Re: Gila River Indian Community Comments on the Draft Class III
Underground Injection Control Area Permit for the Proposed Florence Copper
Project, Florence Copper Project Production Testing Facility, Florence, Pinal
County, Arizona

COMMENTS OF THE GILA RIVER INDIAN COMMUNITY ON THE DRAFT CLASS III UNDERGROUND INJECTION CONTROL AREA PERMIT FOR THE PROPOSED FLORENCE COPPER PROJECT PRODUCTION TESTING FACILITY

Subject: Florence Copper Project – Technical Aspects of the EPA Underground Injection Control Well Permit

Figure 2 - BHP Pilot Test Wells and MODFLOW Grid Used to Simulate Flow and Particle Tracking

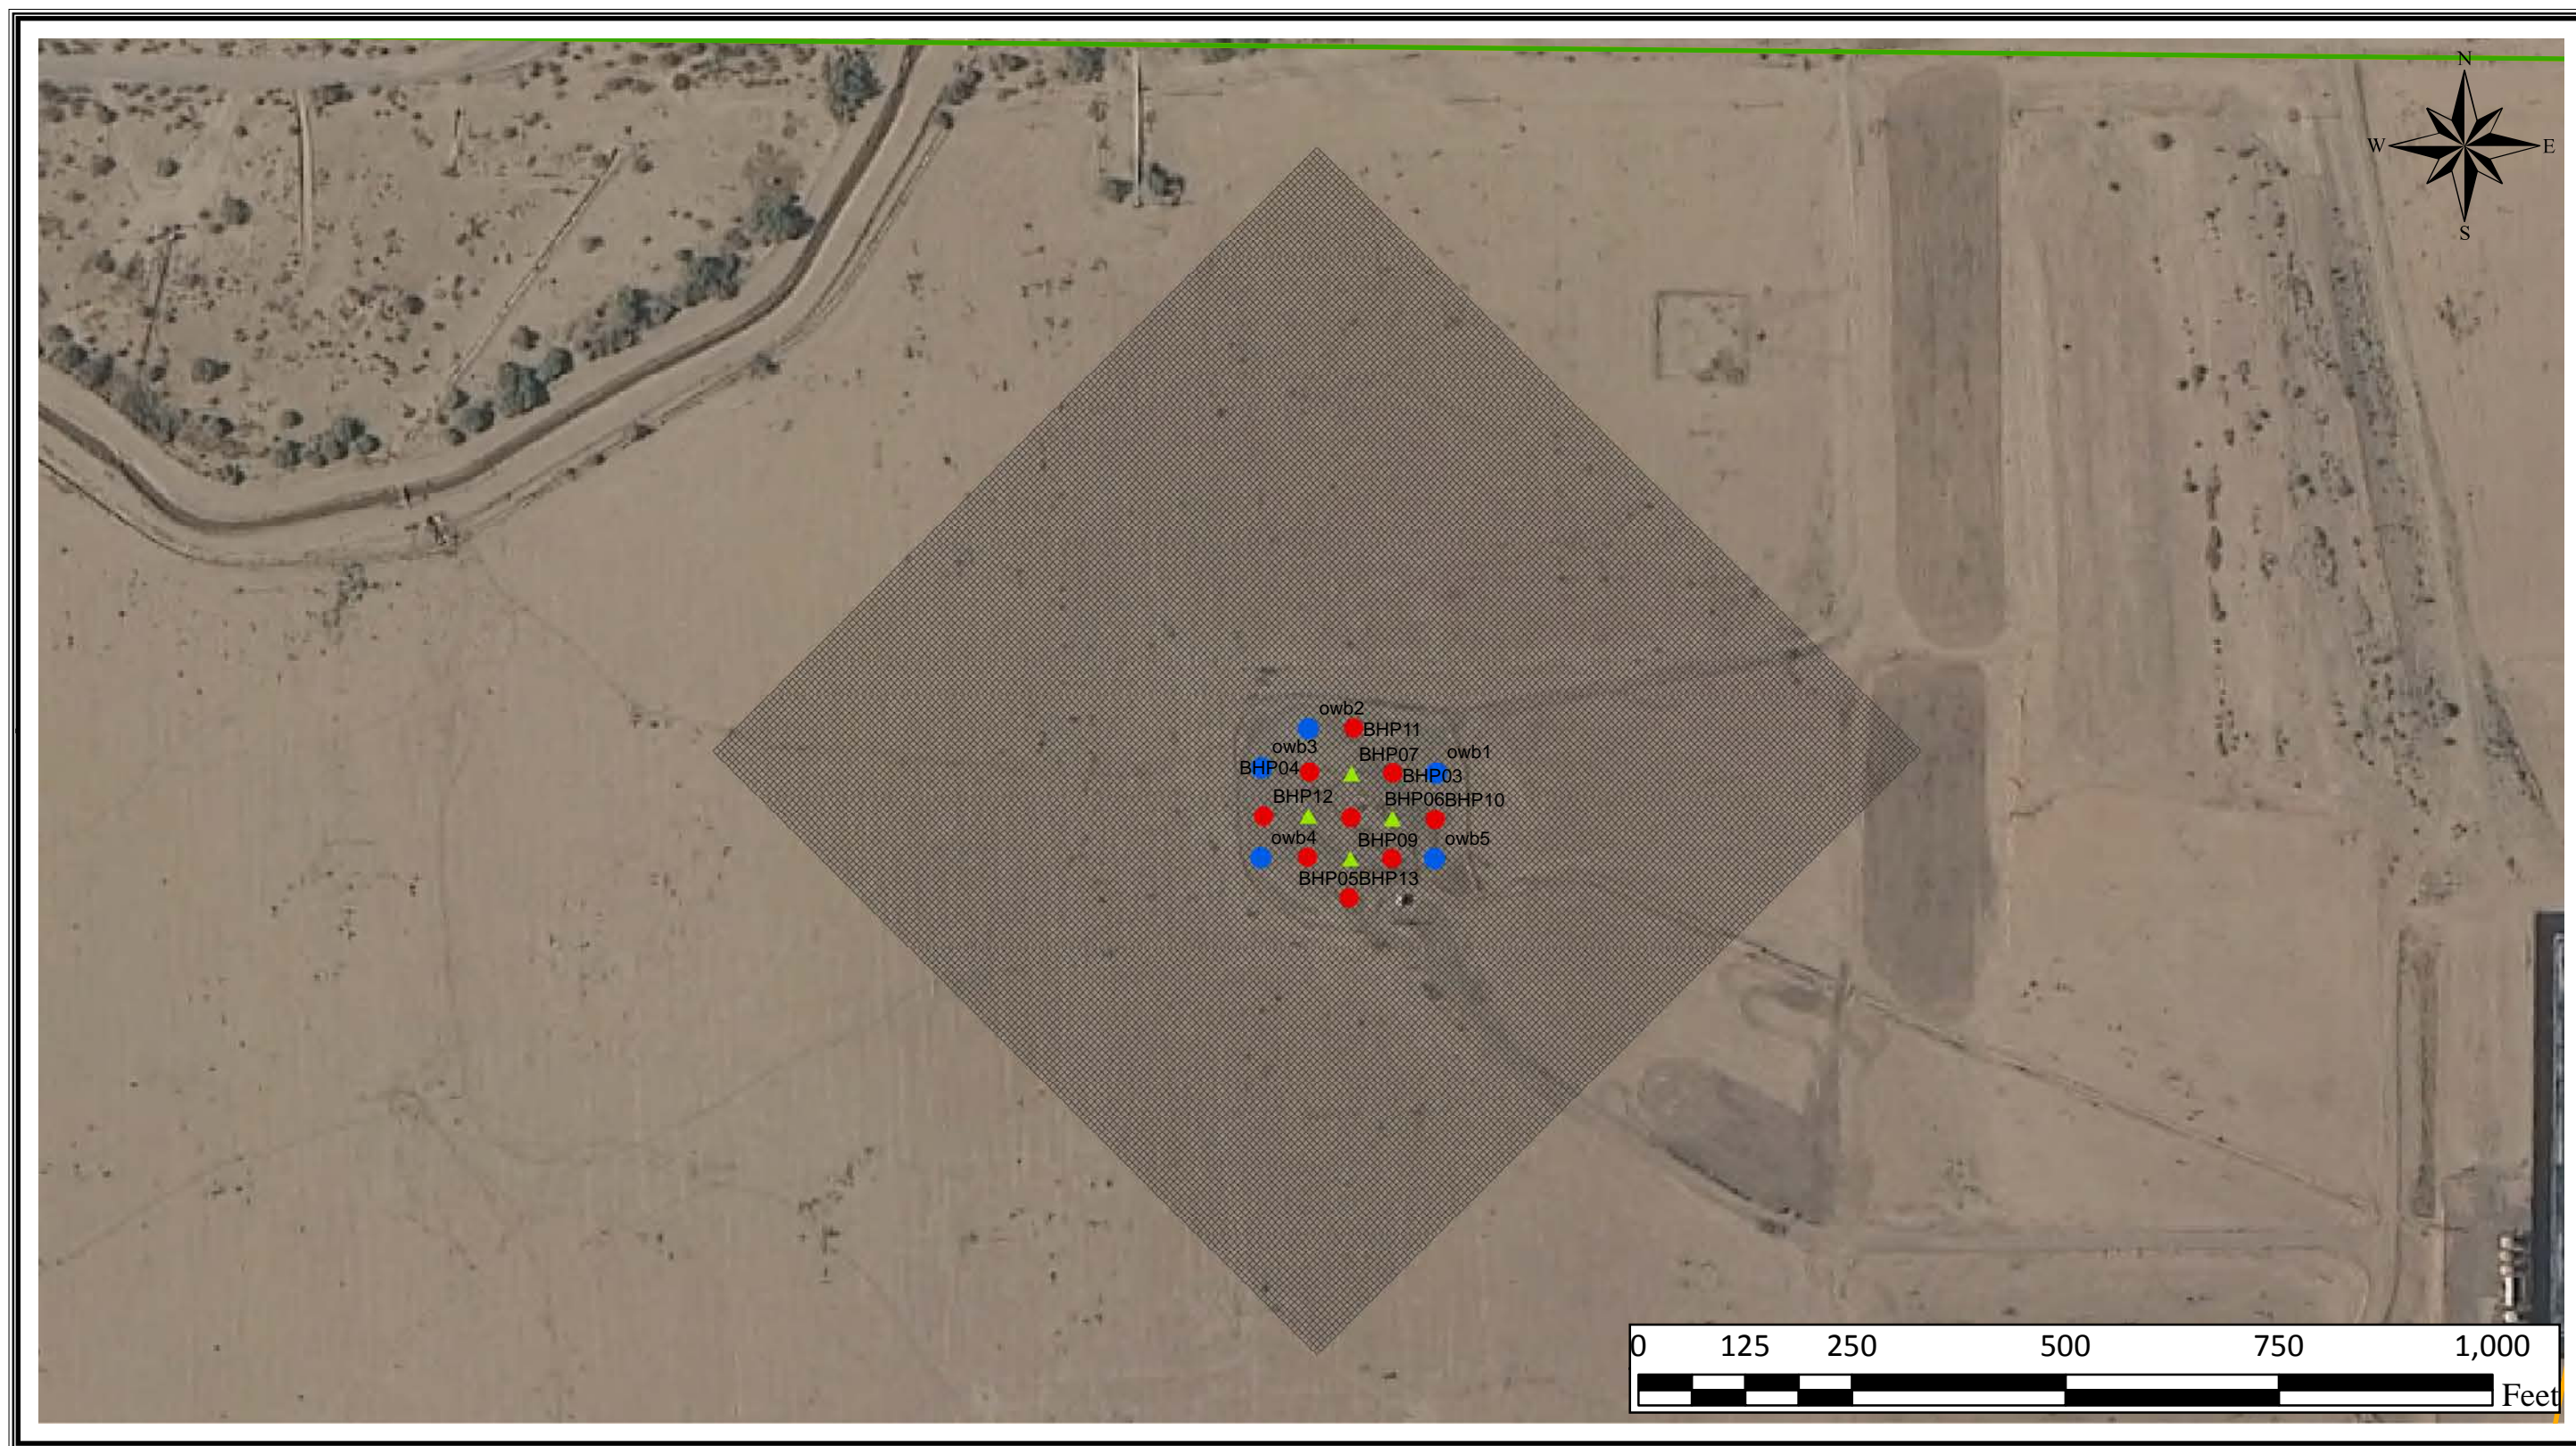
I developed a similar MODFLOW2005 model (same 1000 foot by 1000 foot area, but uniform 6.25-foot square cells) and used it to simulate water levels and the paths of water particles in the top half of the ore deposit starting from the injection wells. See Figure 2 for location of grid for this MODFLOW Model. I did not include the overlying basin fill aquifers in this initial modeling. Water leaking down from these aquifers would lead to less drawdown due to pumping at extraction wells than simulated here and therefore the potential for escape between extraction wells found here would be increased.

Figure 3 - BHP Test Conditions - Uniform Hydraulic Conductivity - Particle Tracks

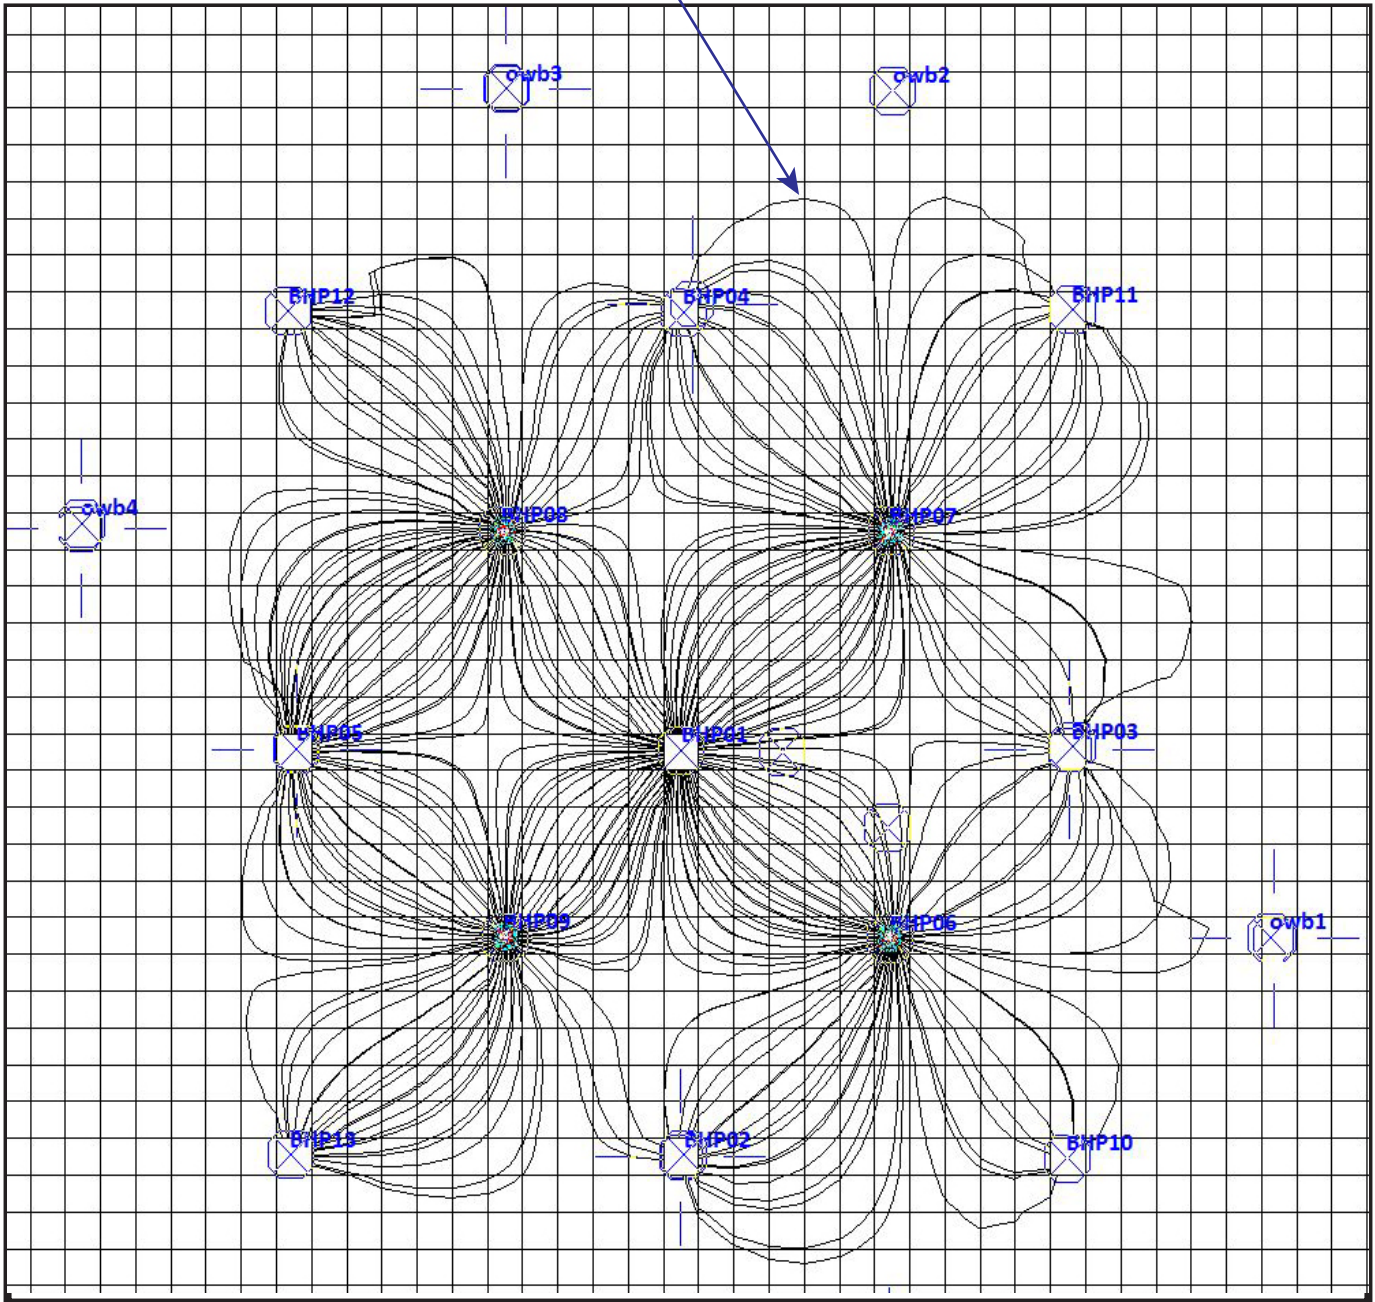
When a uniform value of K was used, the simulated tracks of particles indicate that particles starting at the injection wells can escape from between the enclosing extraction wells for the arrangement of pumping rates used during the BHP operations. However, the pumping pulls such particles back into the extraction wells. See Figure 3 for the simulated particle tracks resulting from the case of using a uniform K to simulate the BHP operations.

Figure 4 - BHP Test Conditions - Variable/Calibrated Hydraulic Conductivity Particle Tracks

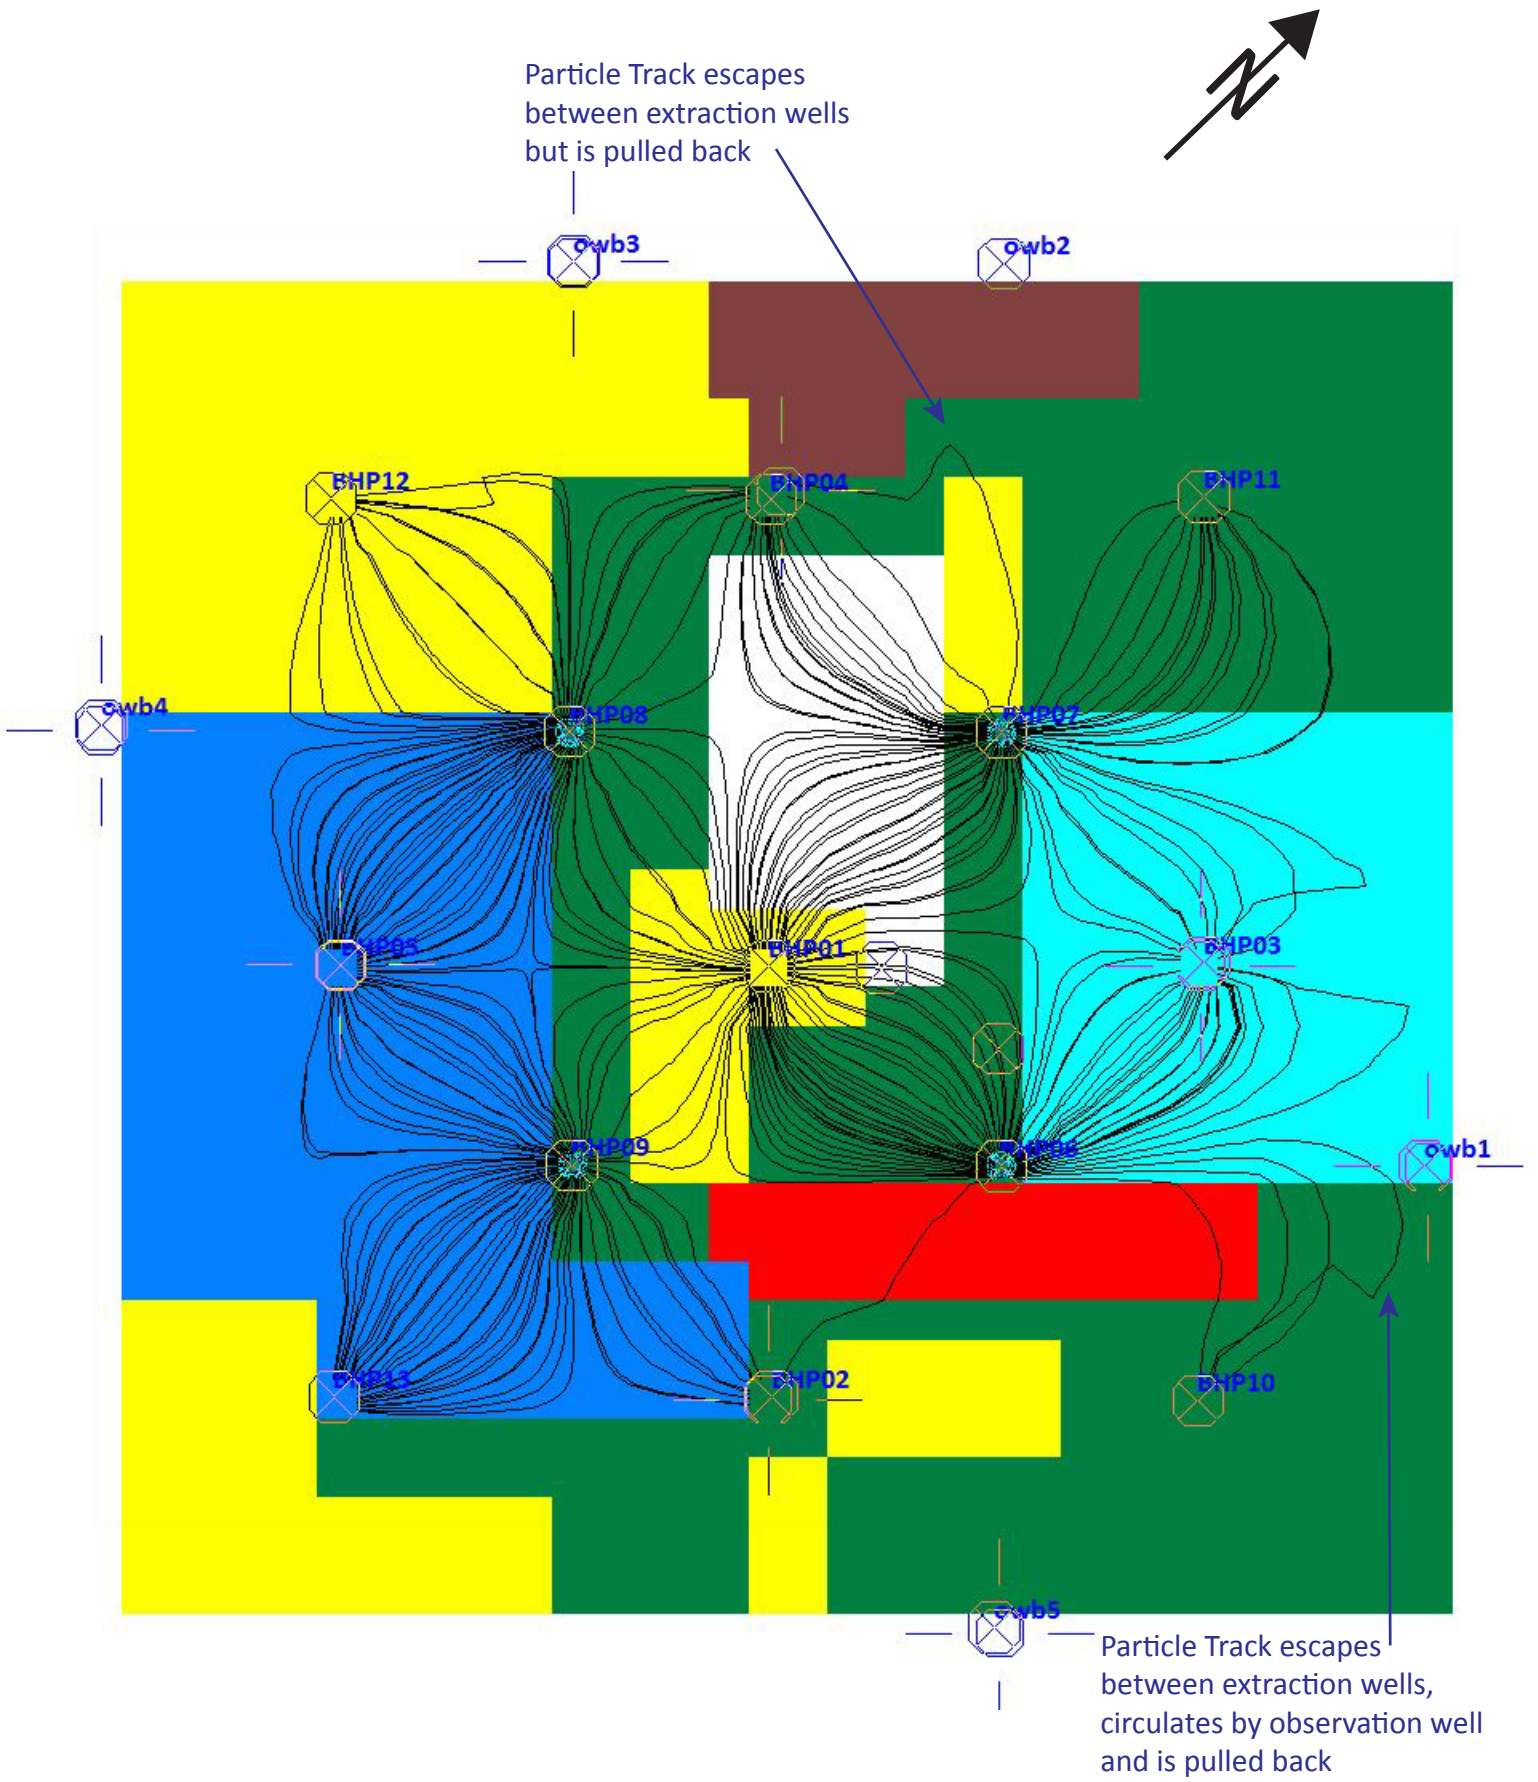
When the calibrated K distribution presented by BHP was used, similar results were found; though there was concentrating and spreading of the particle paths caused by heterogeneity between the injection and extraction wells. See Figure 4 for the simulated particle tracks resulting from the case of using the variable, zoned K distribution from BHP to simulate the BHP operations.

Figure 5 - BHP Test Conditions - Streak in Hydraulic Conductivity - Particle Tracks

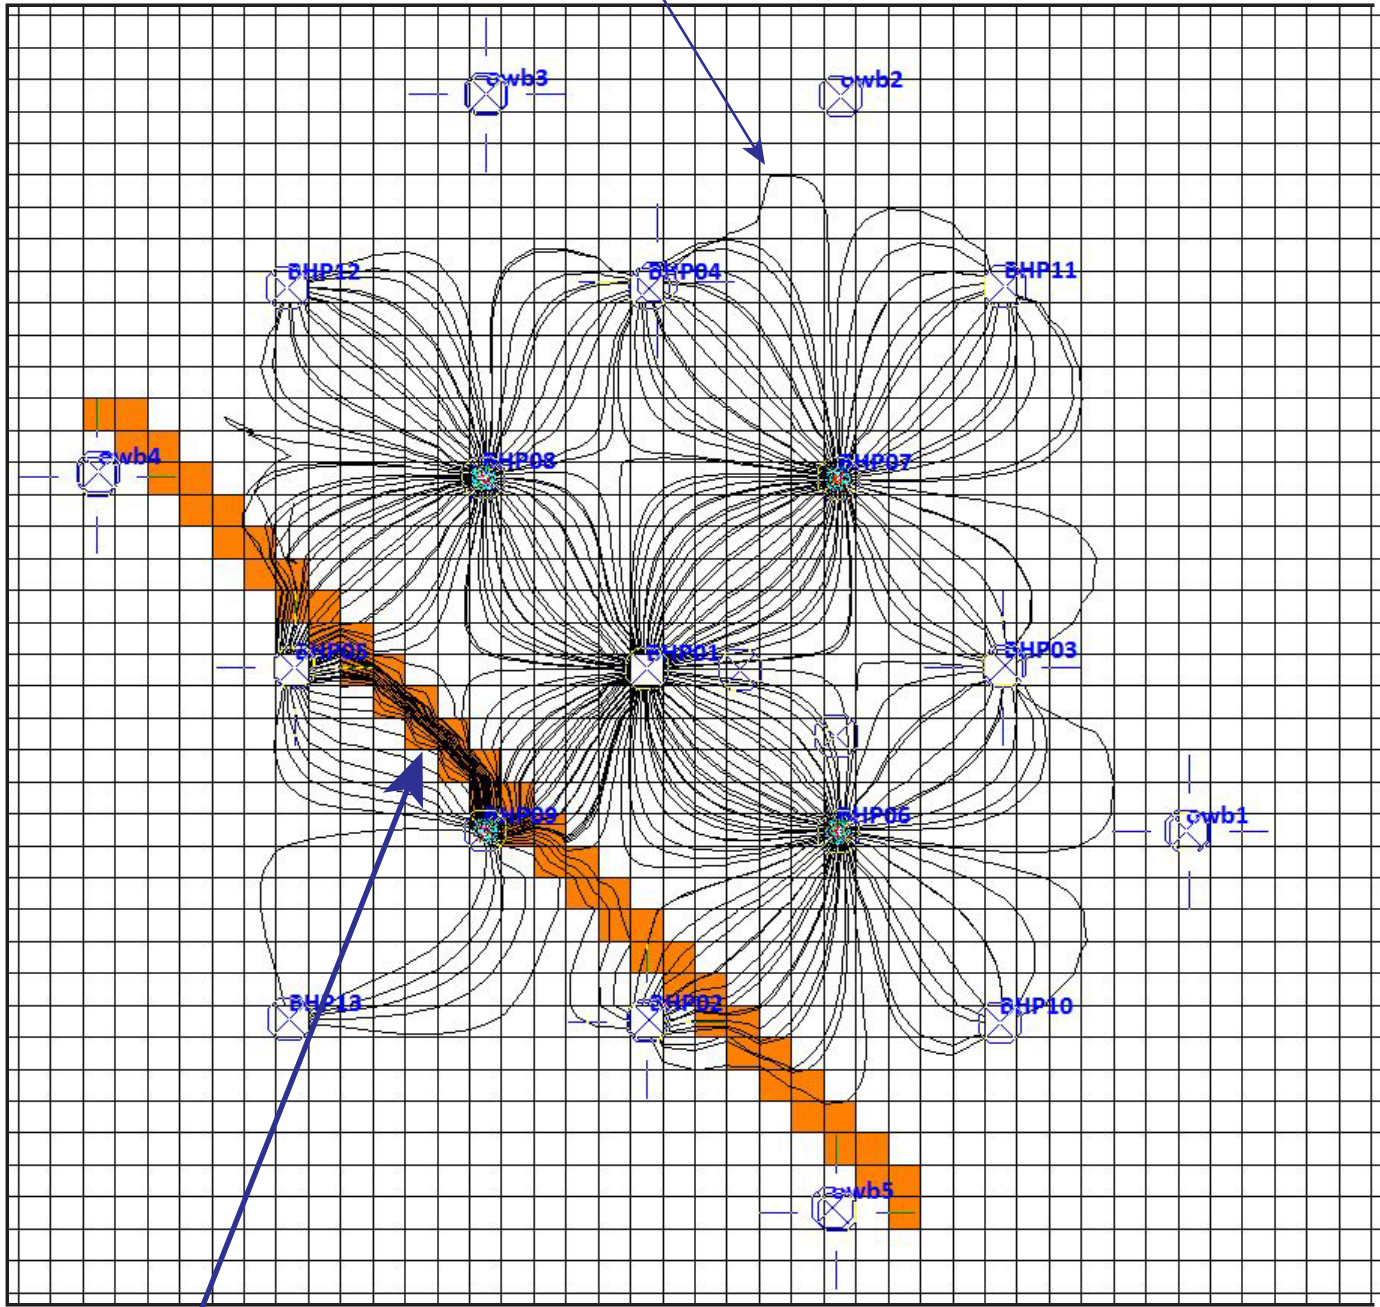
When the streak of high K also presented by BHP was used, the short circuiting between wells BHP 5 and BHP 9 simply concentrated nearby particle paths into the streak. This is a more pronounced version of the effect of heterogeneity also seen in parts of the calibrated K distribution results. The results were similar regarding the escape and recapture as noted for the other two cases. See Figure 5 for the simulated particle tracks resulting from the case of using the streak of high K from BHP to simulate the BHP operations.
